No. 0635-159, Rev. I
ATA Code 73-20

SUBJECT: FLIGHT CONTROLS - ENGINE CONTROLS - INSTALLATION OF SPACER BETWEEN BRACKET AND MIXTURE CONTROL CABLE CLAMP.

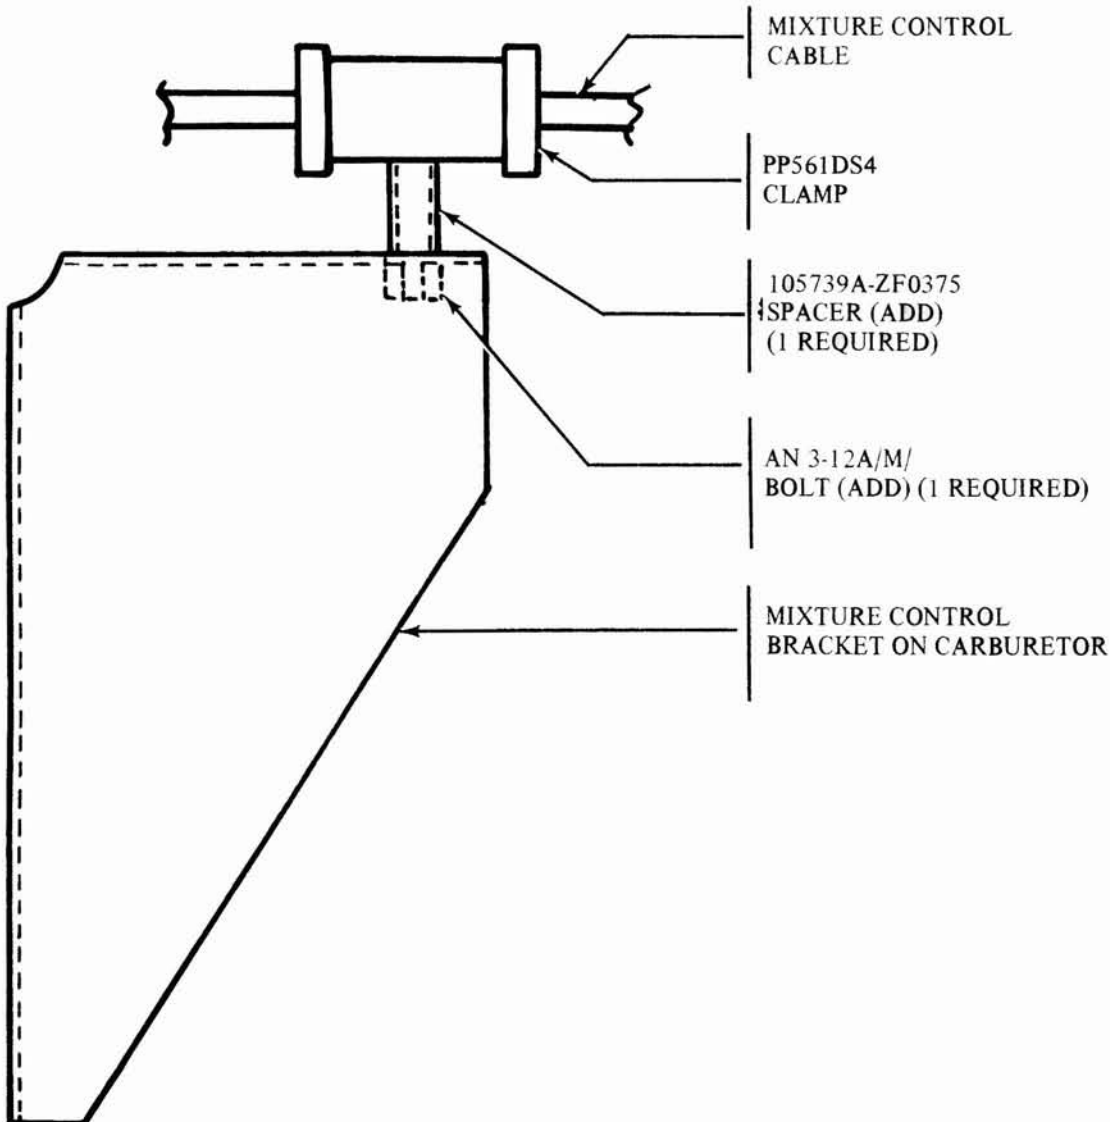
DESCRIPTION: A spacer is installed between the mixture control bracket on the carburetor and the mixture control clamp.

1. Remove the lower engine cowling.
 2. Remove the AN3-7A bolt securing the mixture control cable clamp to the mixture control bracket on the carburetor. Discard the AN3-7A bolt.
 3. Place the new 105739A-ZF0375 spacer between the clamp and bracket. Using the new AN3-12A/M/ bolt, install the clamp to the bracket. See illustration.
 4. Install the lower engine cowling.
-
